DARWIN CITY COUNCIL

TOWN PLANNING COMMITTEE

Town Planning Committee Meeting – Wednesday, 06 May, 2009**8 DEVELOPMENT APPLICATION****8.1 Development Application Lot 3492 (117) Mitchell Street, Lot 3493 (10) Doctors Gully Road and Lot 5684 (3) Daly Street, Larrakeyah – Town of Darwin. 63 X 1 Bedroom Serviced Apartments, 1 X 2 Bedroom Multiple Dwelling (Caretaker's Residence and a Cafe/Restaurant in an 8 Storey Building Plus 2 Levels of Basement Carparking.**

A Development Application for Lot 3492 (117) Mitchell Street, Lot 3493 (10) Doctors Gully Road and Lot 5684 (3) Daly Street, Larrakeyah has been referred to Council for comment pursuant to Section 48 of the Planning Act. The following report addresses relevant Council issues and recommends that Council endorses the comments provided to the Development Consent Authority by staff.

EXISTING & PROPOSED SITE PLANS : 1:50

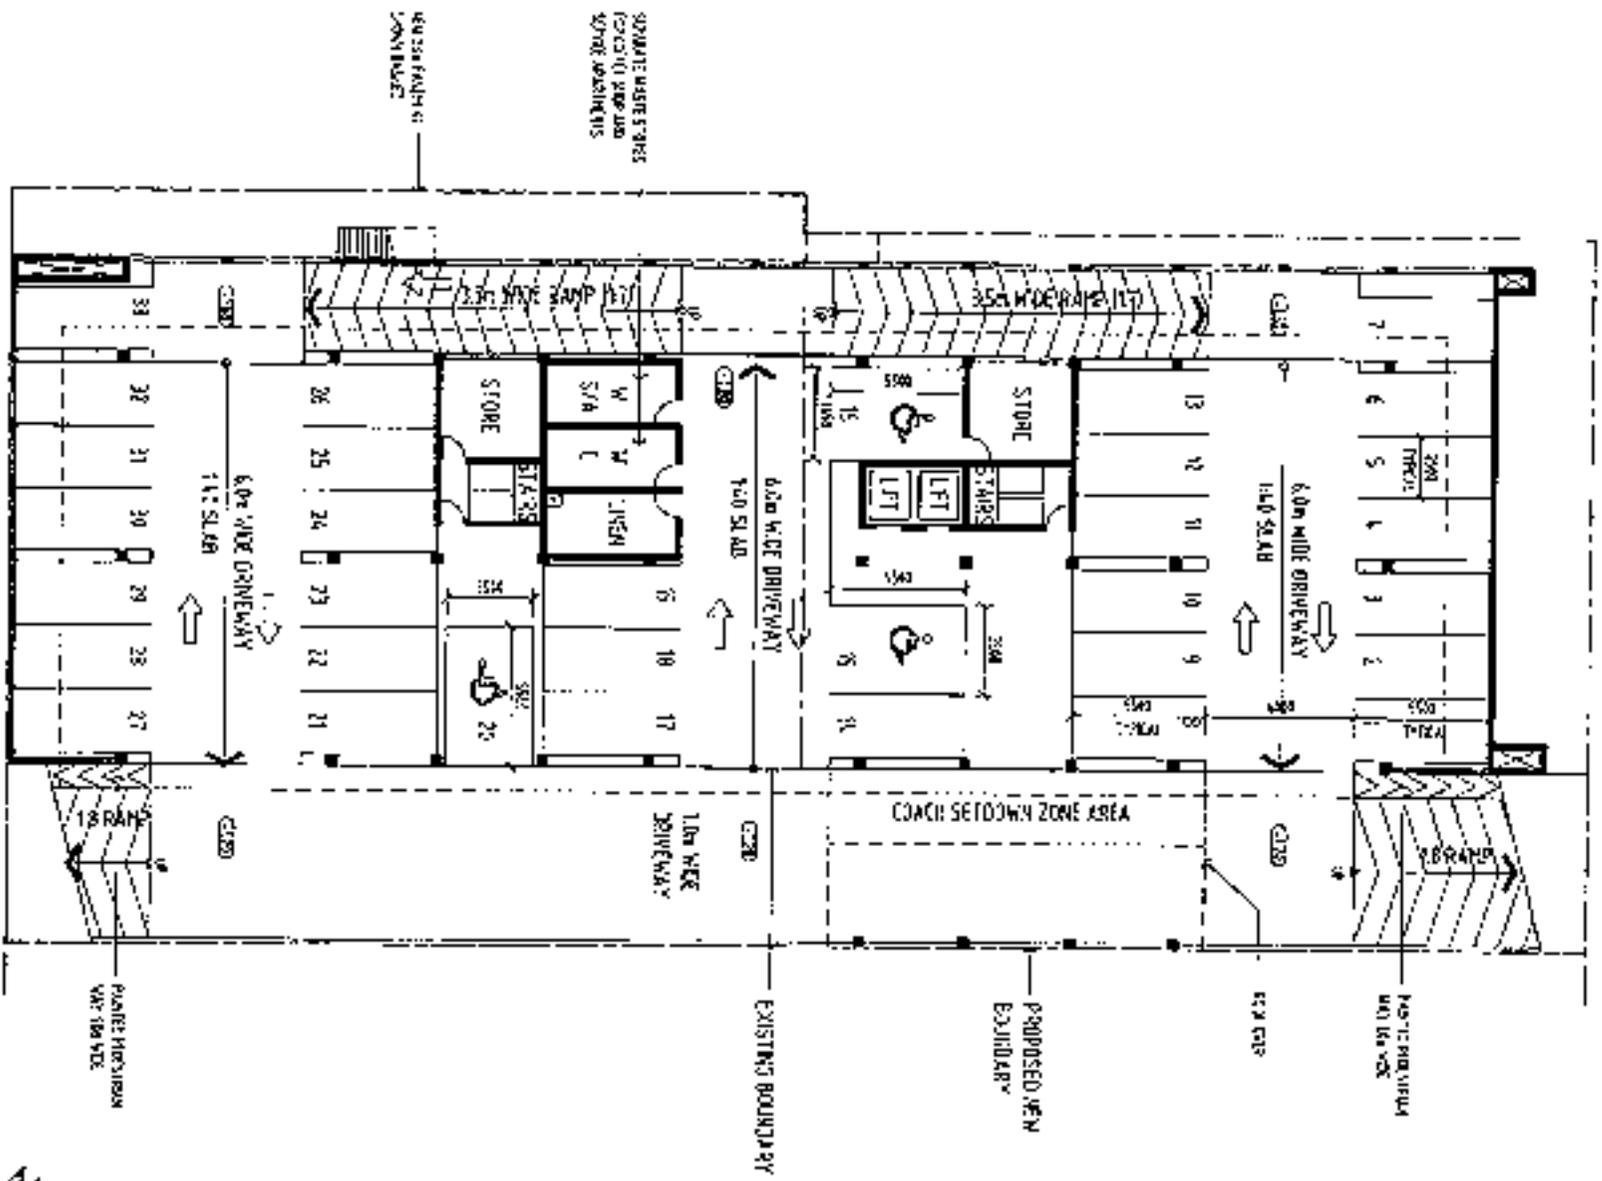
- b). **Council requests the Authority requires a schematic plan to demonstrate how stormwater will be collected on the site and discharged underground to Council's stormwater drainage system.** The drainage plan should include details of site levels and Council's stormwater drain connection point/s within the vicinity of the site. Council requires a stormwater drainage plan to confirm that it is technically feasible to collect stormwater on the site and dispose of it into Council's stormwater drainage system. It is also necessary to ensure that no stormwater will sheet-flow into the road reserve or onto adjoining properties.

BASMENT CARPARK LEVEL 1 FLOOR PLAN 1:100

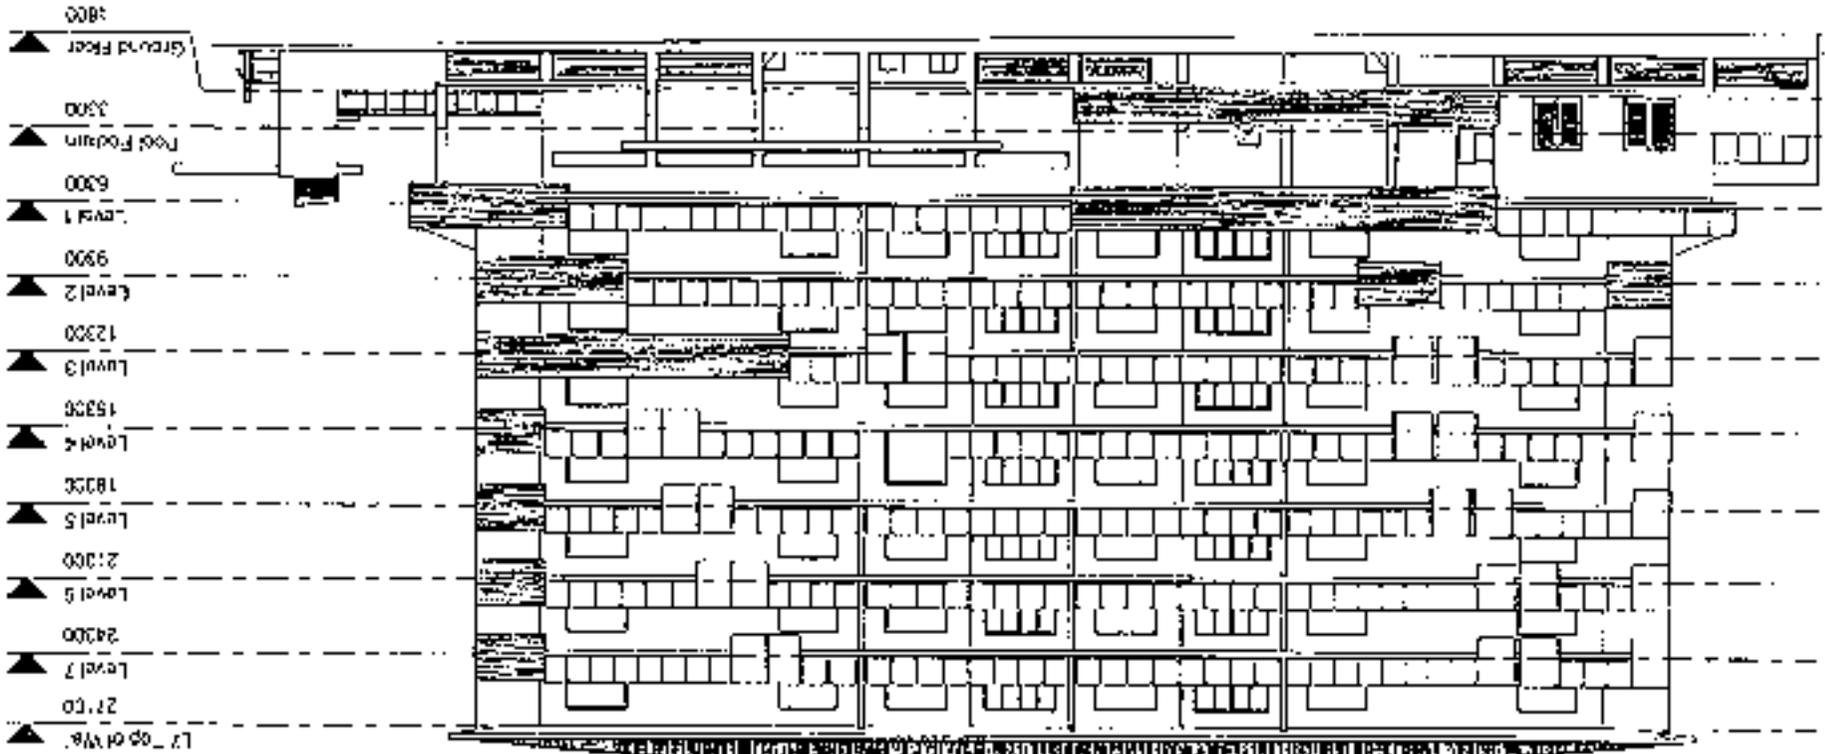
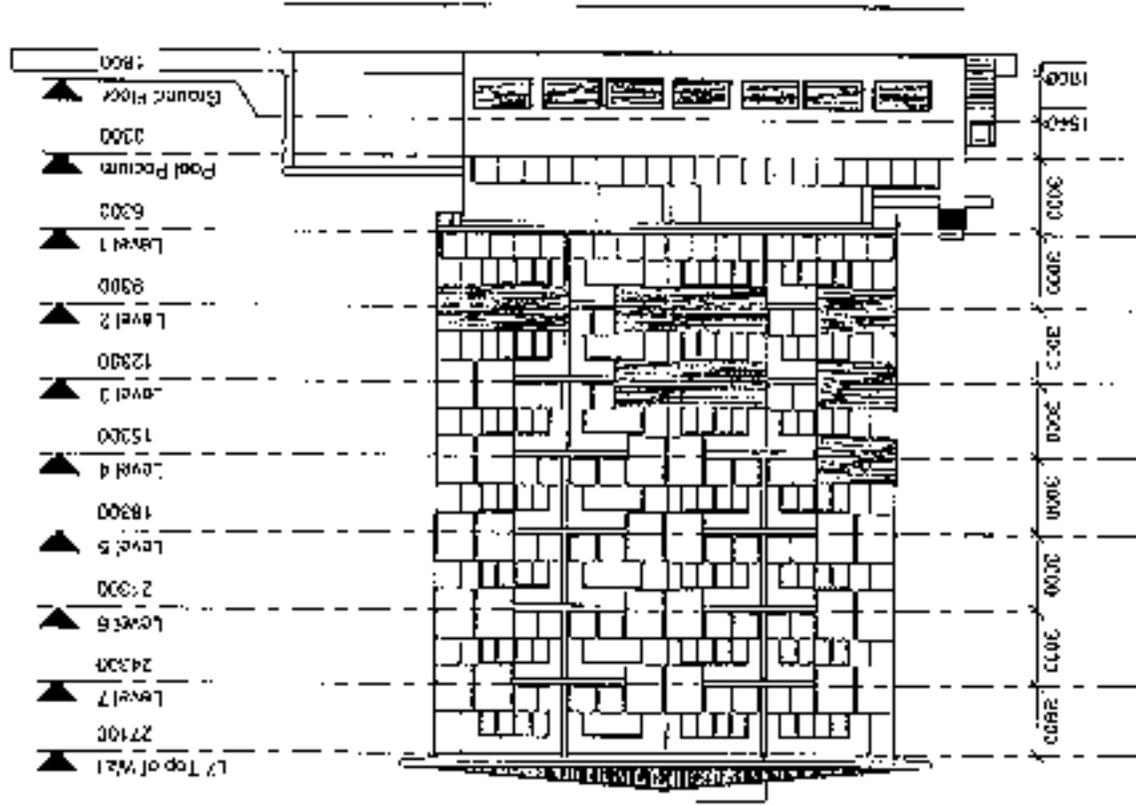
- a). **Council requests the Authority requires amended plans demonstrating waste management facilities in accordance with Council's requirements.** This current proposal does not meet Council's requirements for the following reason:
- 1). High rise residential developments of six storeys or more should include garbage chutes for waste disposal and have a separate recycling collection facility. The development application plans indicate separate waste storerooms for the serviced apartments and coffee shop within the basement car park, but no garbage chute is proposed.

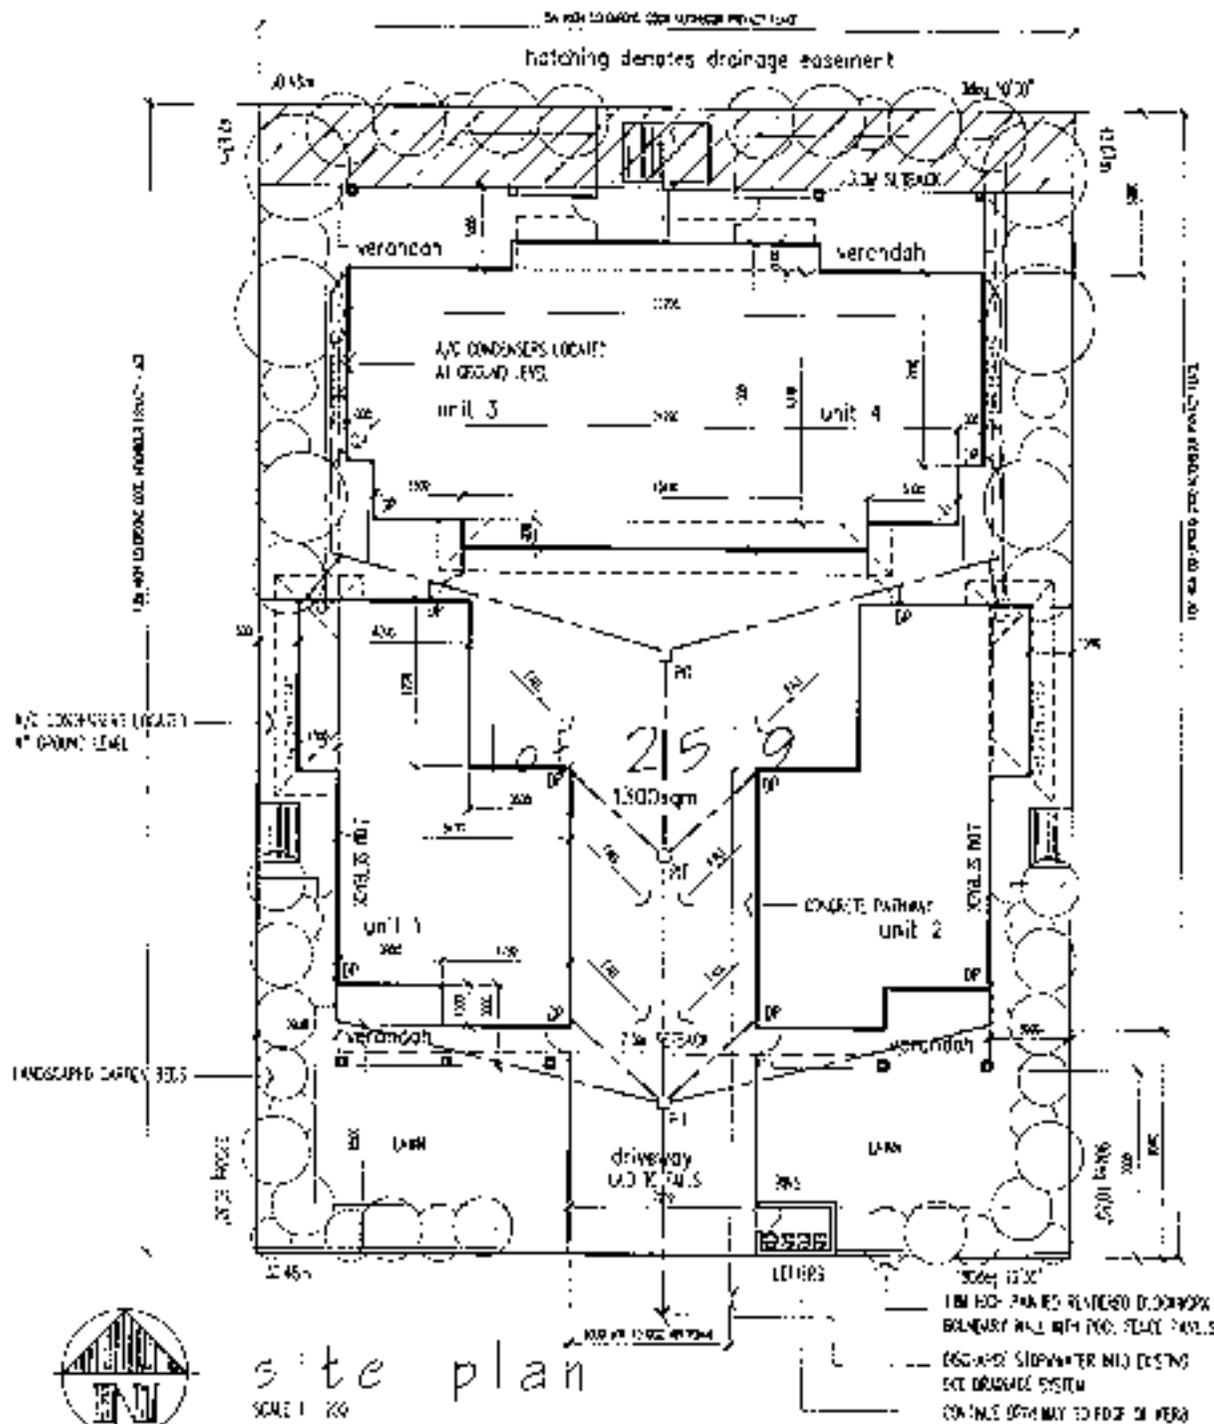
- a). The applicant's site plan demonstrates a 3-metre wide drainage easement running along the rear boundary of the site. Council has no records of any drainage easement in this location. The developer needs to establish the existence of the easement by way of a title search. The title search would also reveal in whose favour the easement has been made.
- b). **Council requests the Authority requires a stormwater drainage plan that provides the technical information required by Council to assess stormwater drainage proposals for the development.** The plan should demonstrate how stormwater will be collected on the site and connected to Council's drainage system. The plan should include details of site levels and Council's stormwater drain

- a). **The proposed 6-metre wide crossover and driveway from Voyager Street appears to meet Council's requirements.**
- b). Council notes from the applicant's Site Plan that the waste bin enclosure and letterbox structure are proposed on the front boundary of the site, adjacent to the vehicle driveway. Council requires that a condition is placed upon any development permit to require that vehicle sight lines shall be provided at crossovers to public streets to the satisfaction of the General Manager of Infrastructure, Darwin City Council. No wall, fence or tree exceeding 0.6 metres in height shall be constructed or planted in front of the sight line. The wording of the condition is included in the list of general conditions below.
